Addendum No. 2

IFB-25-00071 Thonotosassa Fire Station #21

SOLICITATION TITLE: **Thonotosassa Fire Station #21**

CONCRETE MAT
EDGE DETAIL

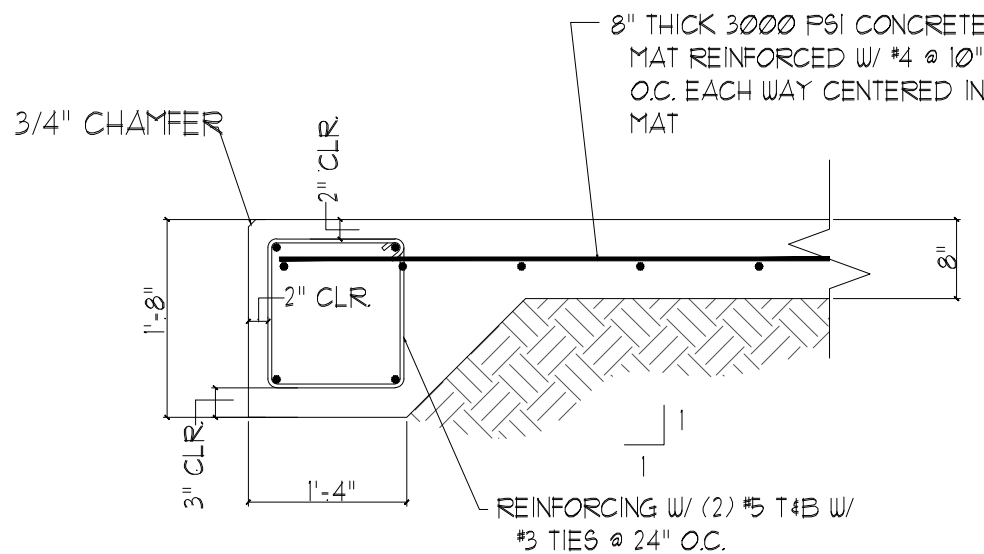
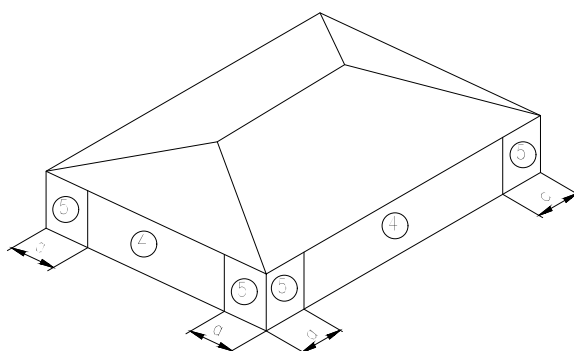
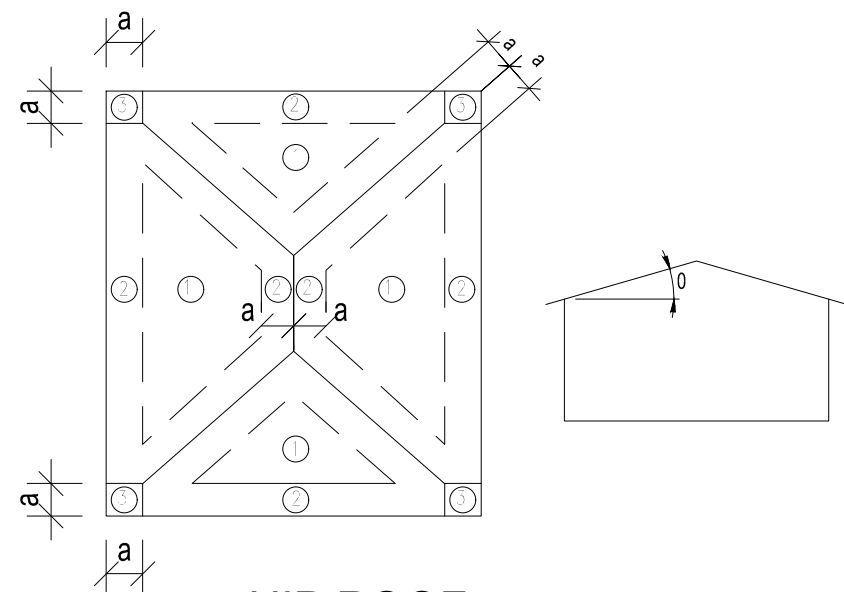
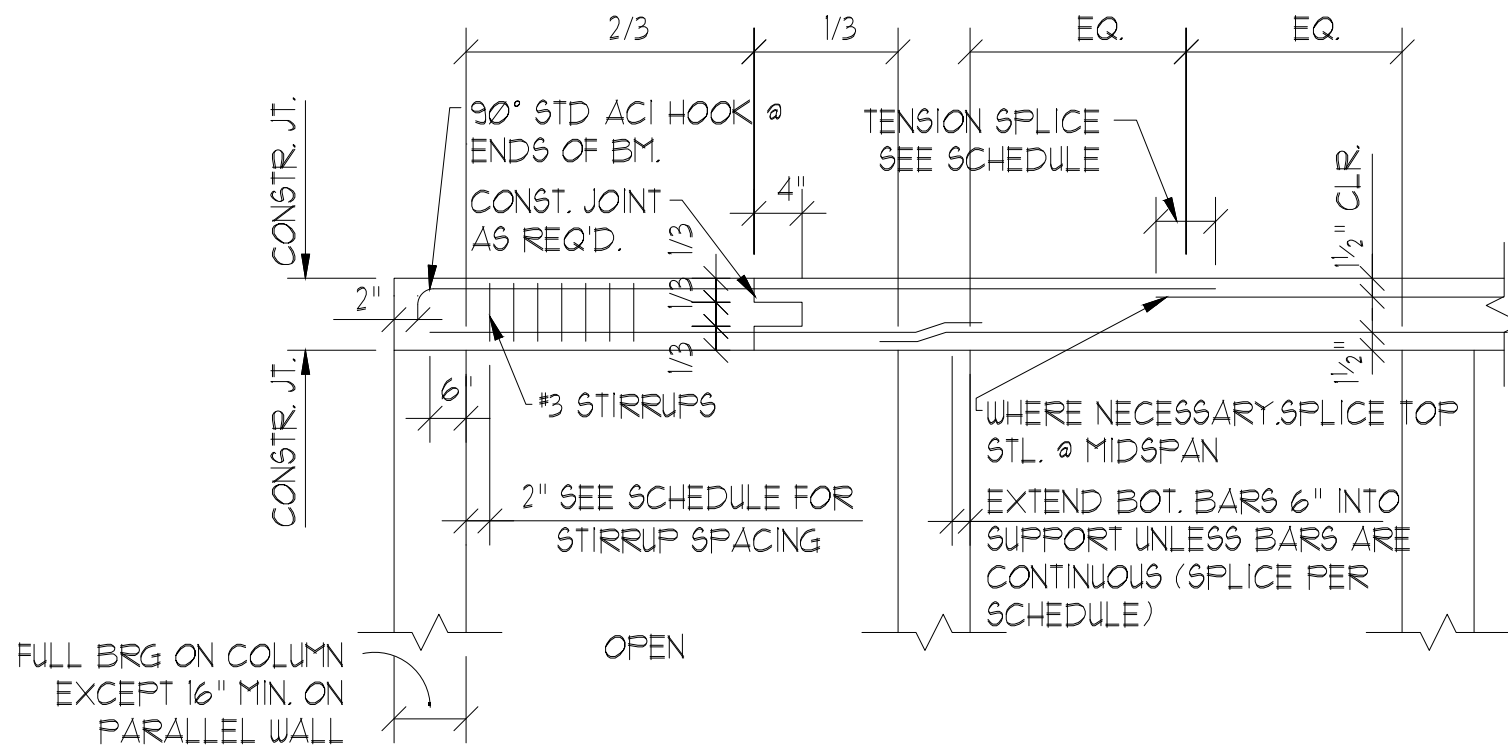
Question No.8: Please provide structural details for the fire tank / well, storage shed, diesel fuel tank/dispenser and fire pump house foundation/slab.

Response: Detail added to revised sheet S0.2 as part of this Addendum 02, dated 03.06.2024
